Brewery Yard, Central Park Sydney

Response to Submissions: City of Sydney

Response to City of Sydney Submission

These notes are prepared in response to comments made by the City of Sydney in relation to SSD-9374 and it should be read in conjunction with related correspondence by Ethos Urban and associated consultants.

CS07

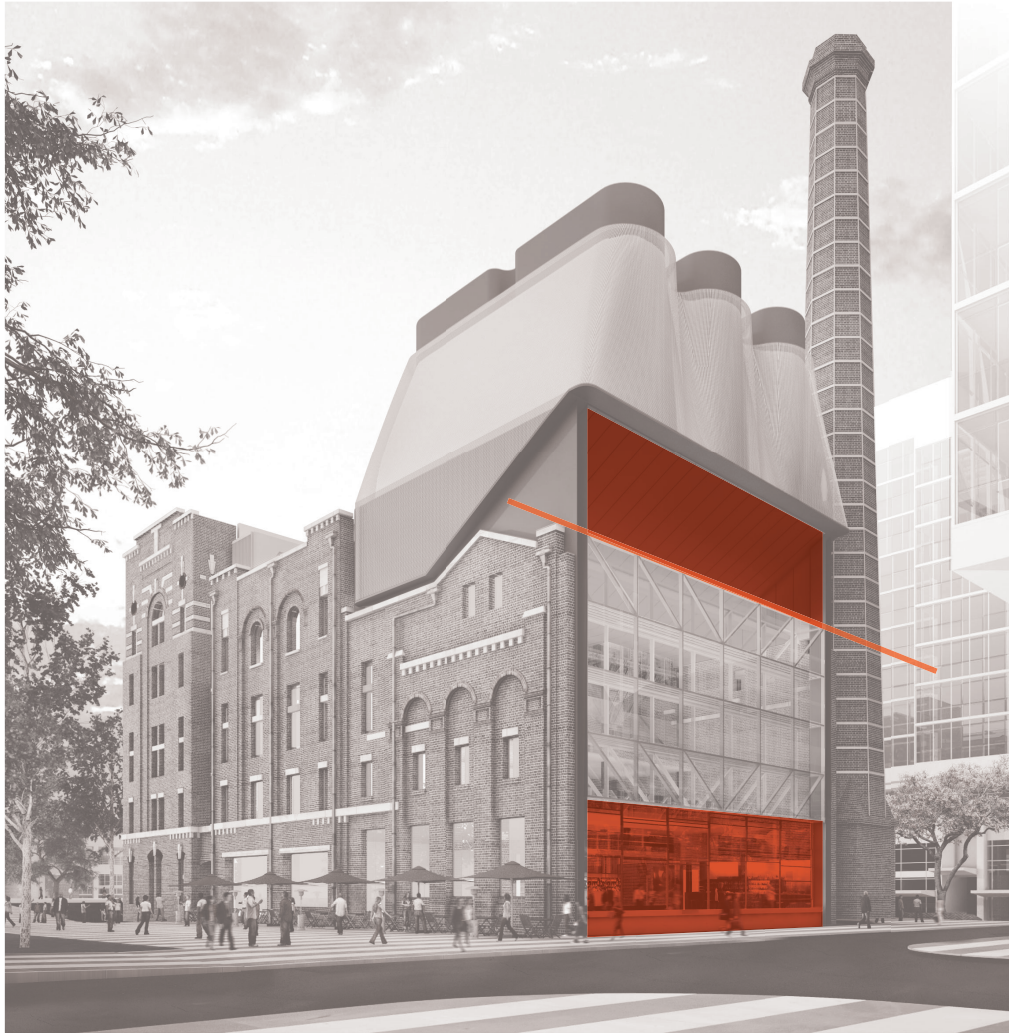
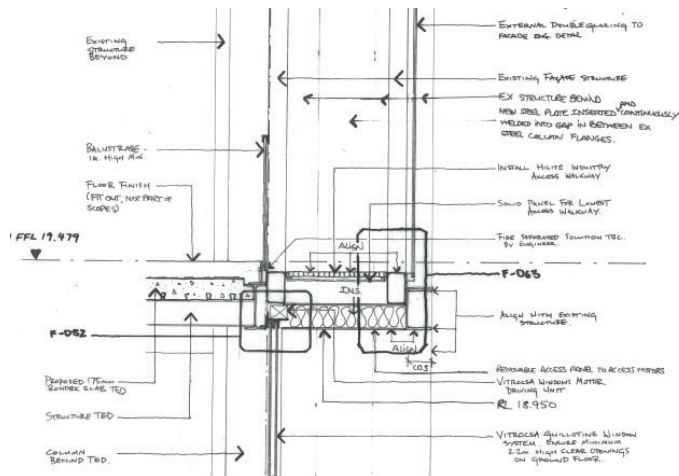
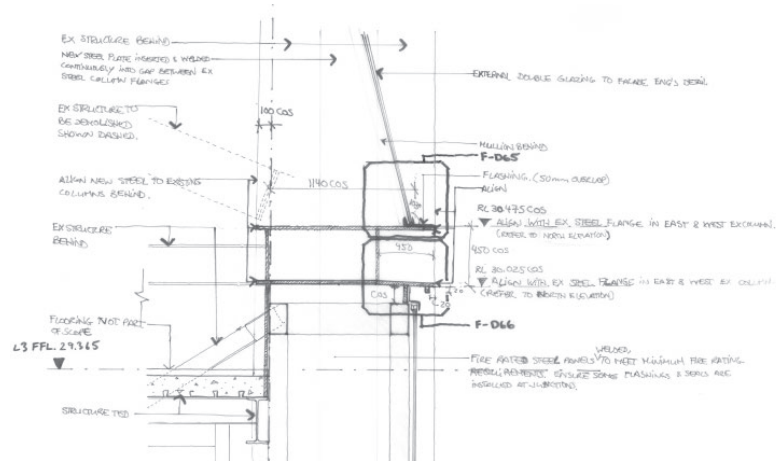
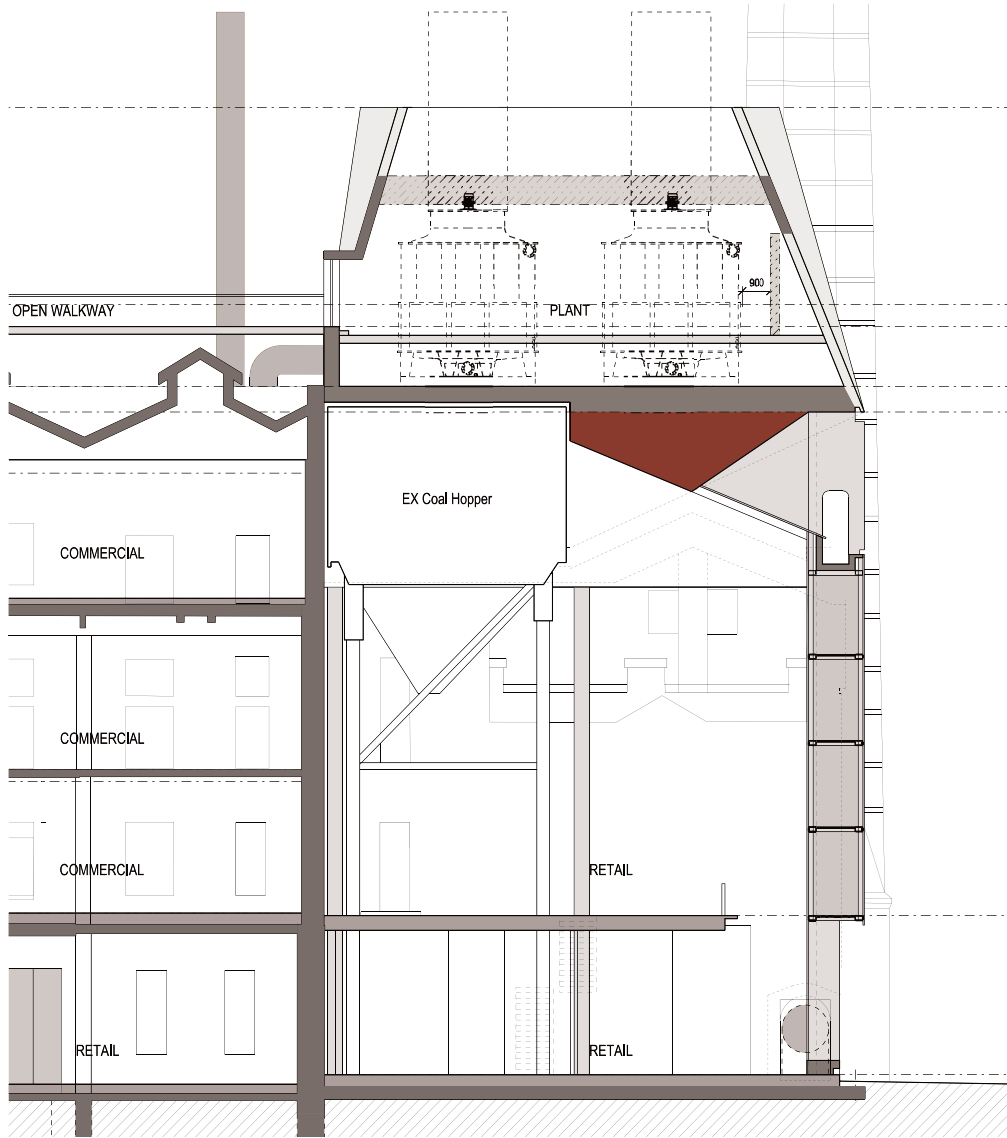
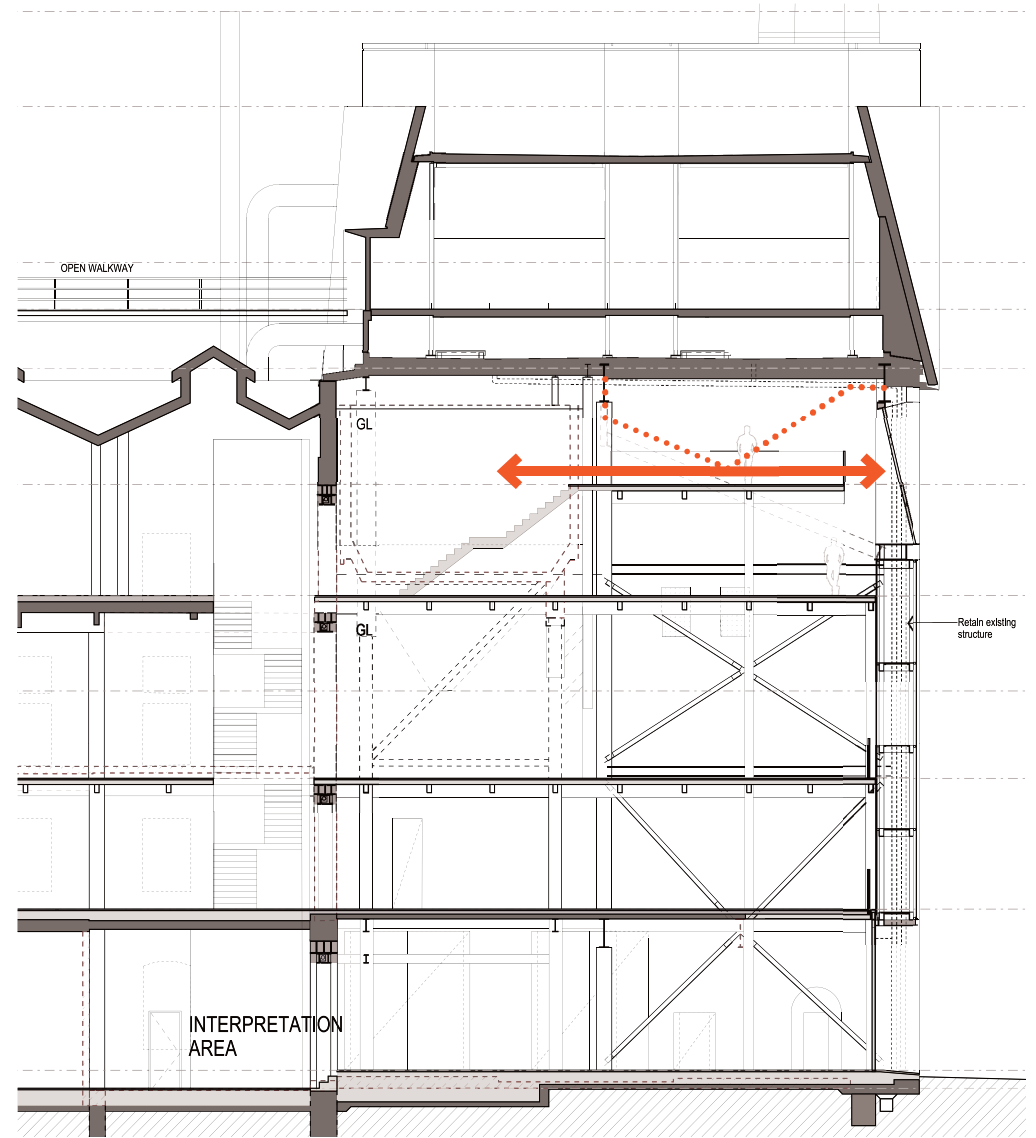
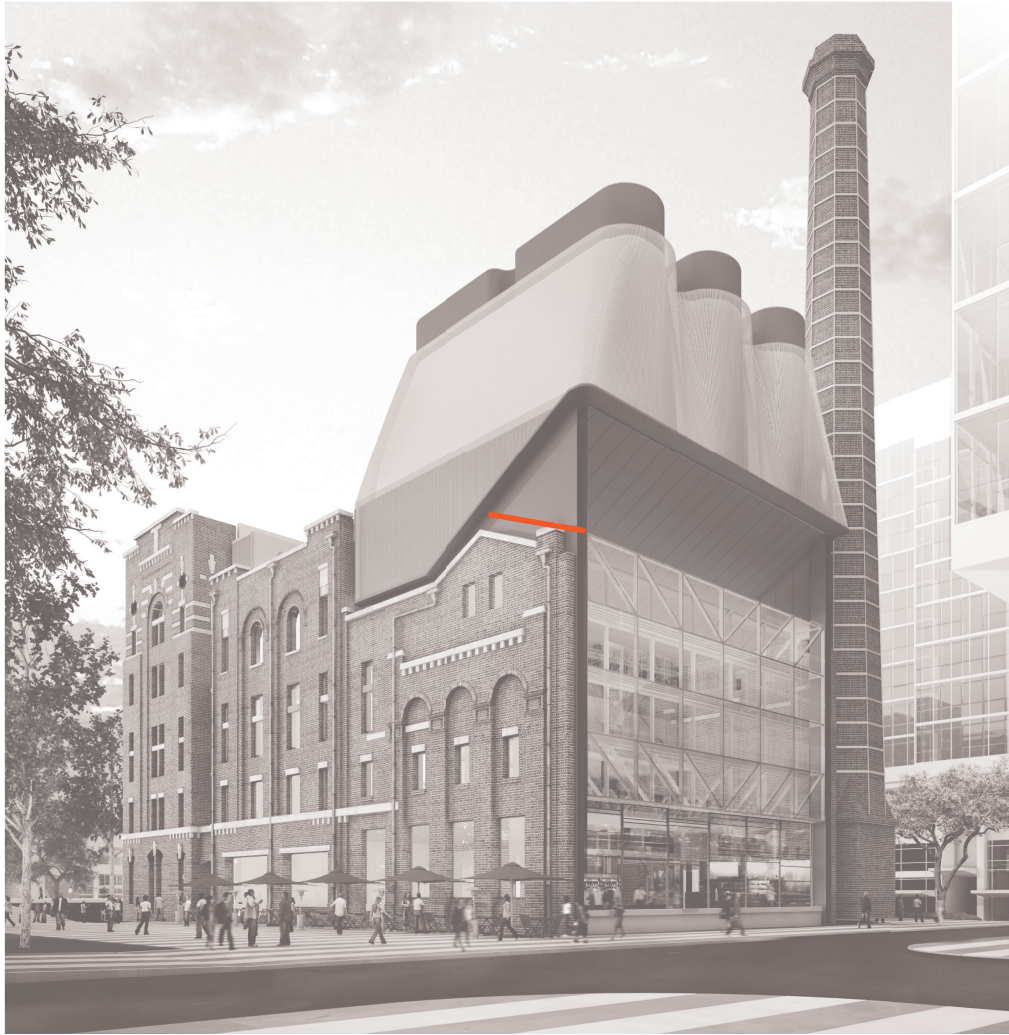
Building 30 North Facade

The design of the north facade has been developed to better integrate the hoppers with the broader space of the northern rooms. Key design principles have driven this design development.

The upper level glazing has been amended to open up the upper level of the hoppers with the northern room. The previous approximate alignment with the old roof line was designed to integrate services requirements below the Tri-Gen plant which is no longer required. This approximate alignment (which was above the old roofline) was not apparent from the public domain.

To improve the design integrity of the northern facade, detailing of the steel work, glazing frames and sloped opening on the upper level is designed to provide a clear articulation and relationship to the existing fabric and building scale.

Ceiling profile no longer required for Tri-Gen services and blocks relationship of the top of the hopper with the broader space of the northern room

Ceiling profile deleted and upper level glazing amended to open up relationship of the top of the hopper with the broader space of the northern room

CS10

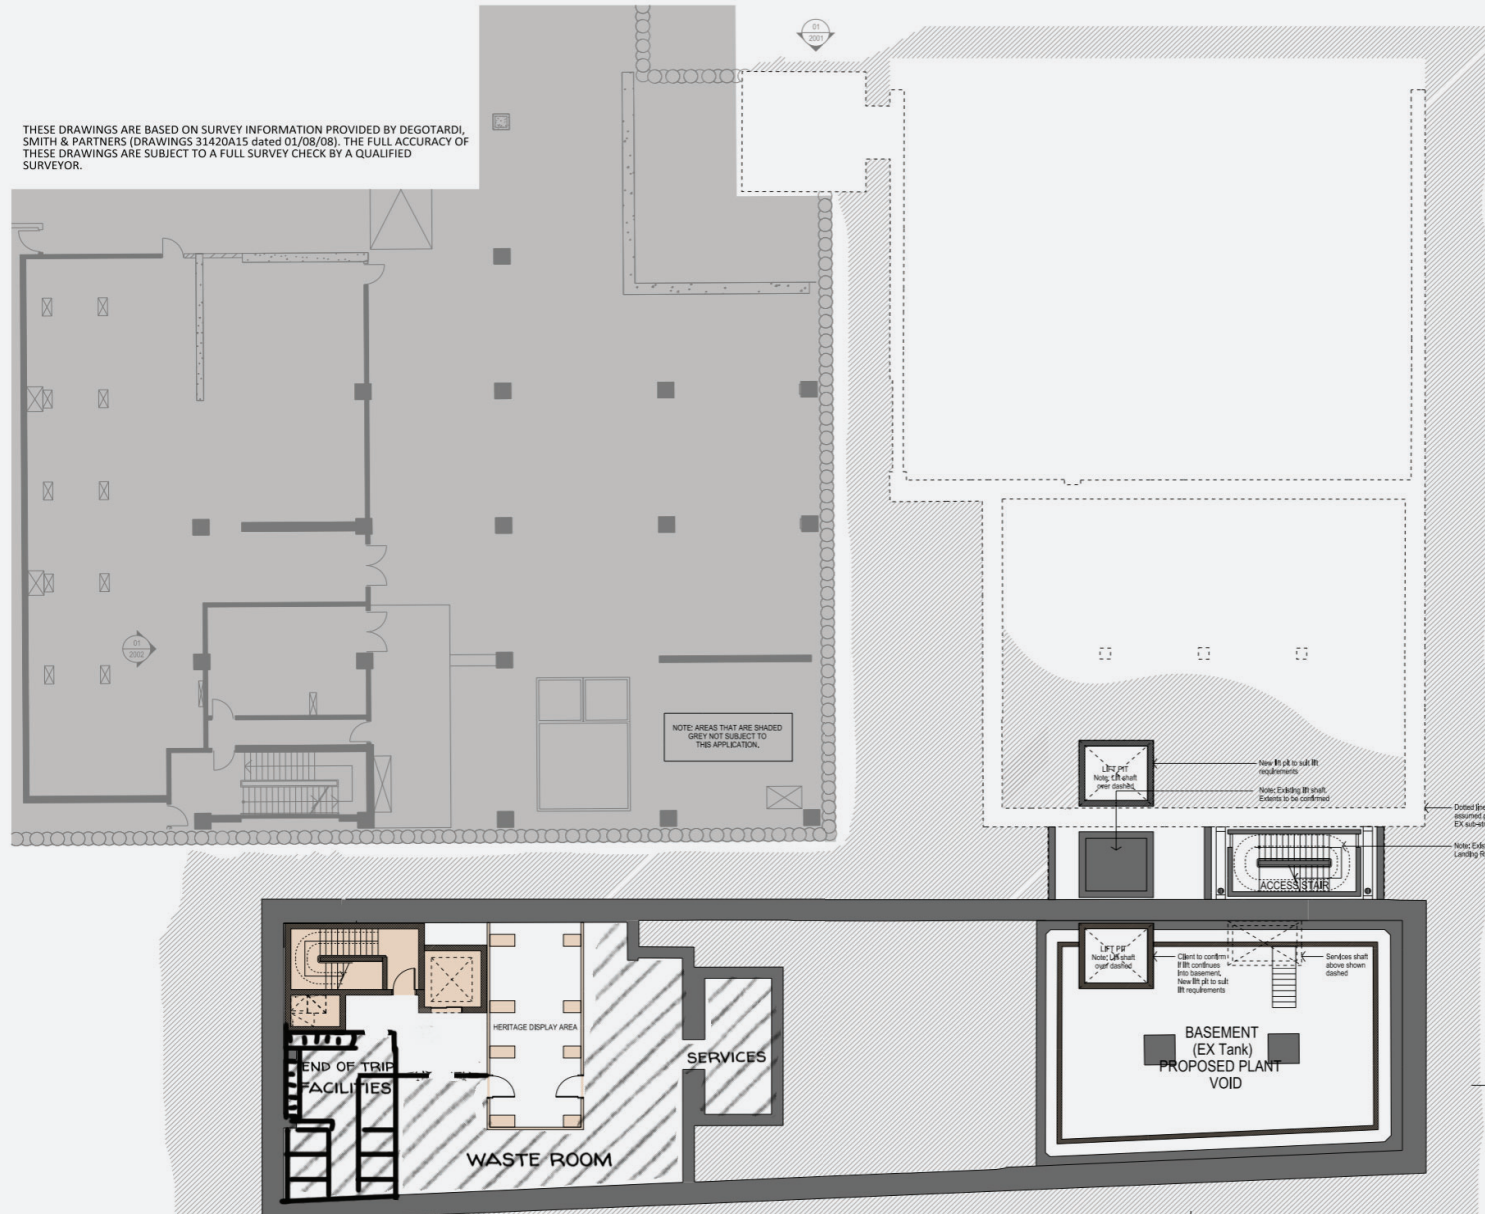
Bicycle Parking and End of Trip Facility

The bicycle storage area is located on ground floor level and easily accessible from lobby space and the through site link. Lockers, showers and change rooms will be located underground with security lockers and surveillance, accessed by the goods lift and stair.

CS14

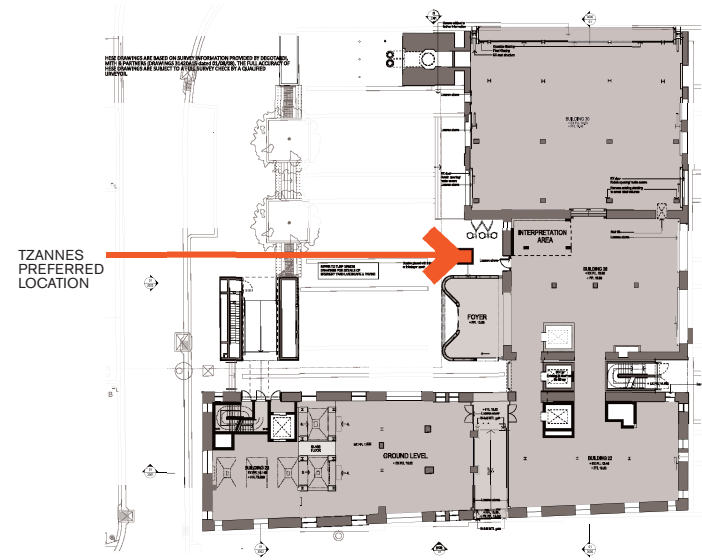
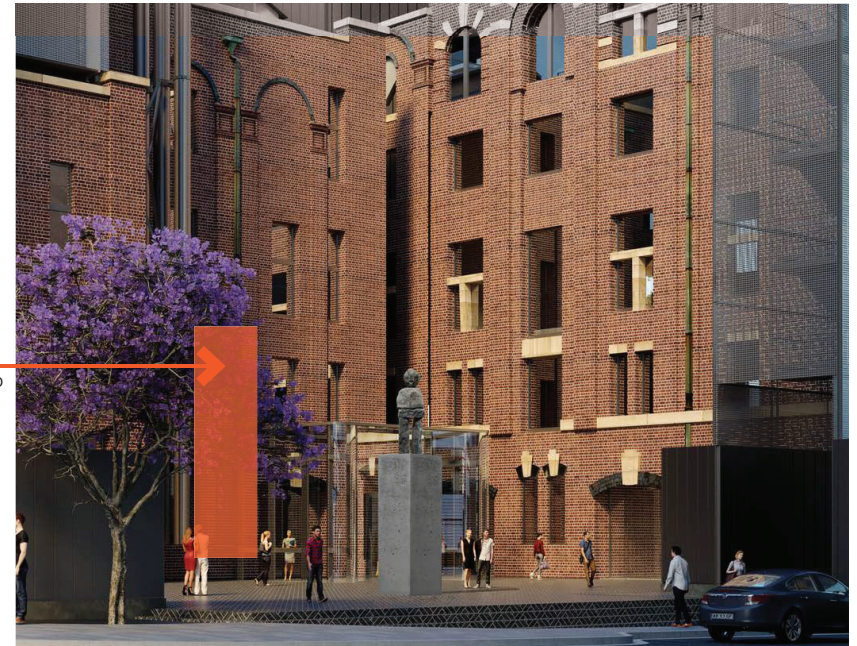
The current proposal by Ugo Rondinone, to be located in the Brewery Yard is called *The Remembered*. The position of this artwork was under discussion with Frasers as the position proposed by Frasers compromises an access easement required to services the Tri-Gen basement.

Tzannes has proposed an alternate location as shown on the adjacent plan. The preferred location remains the same even if the foyer is omitted from the proposal.

Current Public Art design with revised location proposed by Tzannes
